TECHNICAL BULLETIN

TB NO. 1040

Subject: **Revision of Main Bearing Cap on VEE Engines**

P-033-558-C

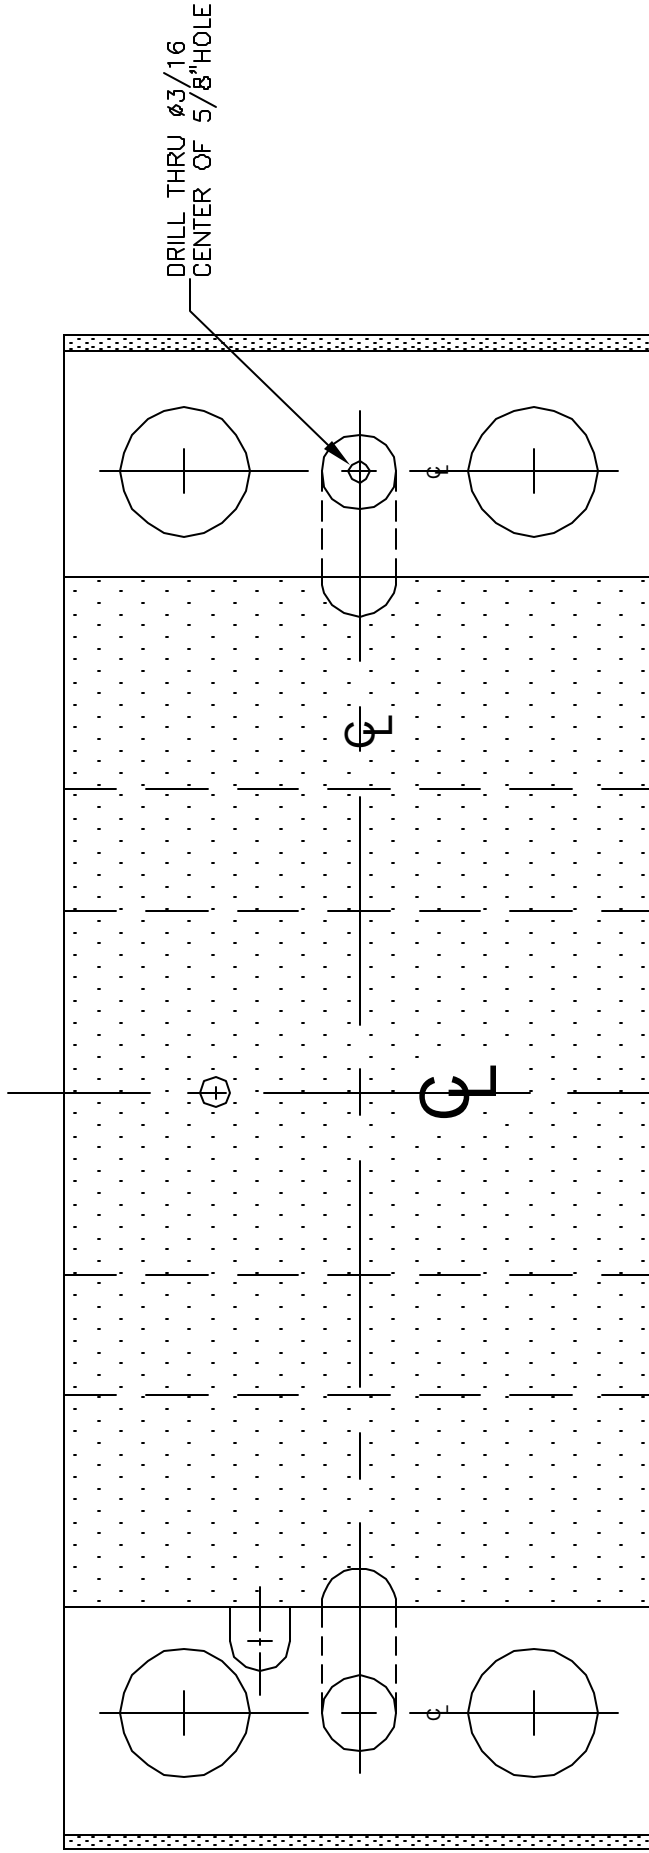
PROBLEM: Some reconditioned bedplates and pre-1972 models do not have the center main cap drilled for oil circulation

- DRILL 3/16" VENT HOLE IN THE CENTER MAIN BEARING CAP AS SHOWN.
- VENT HOLE IS TO PROVIDE OIL CIRCULATION THROUGH THE MAIN BEARING TO IMPROVE COOLING & LUBRICATION AT THIS LOCATION. THIS IS NOT NECESSARY ON THE OTHER MAIN BEARING CAPS SINCE THESE BEARINGS HAVE A THROUGH FLOW IN FEEDING COOLING OIL TO THE PISTONS.
- STAMP TOP OF CAP "CENTER MAIN ONLY"

SOLUTION: Modify center main cap for oil vent

Please refer to EnDyn drawing **P-033-558-C** for the proper size and location of the vent hole.
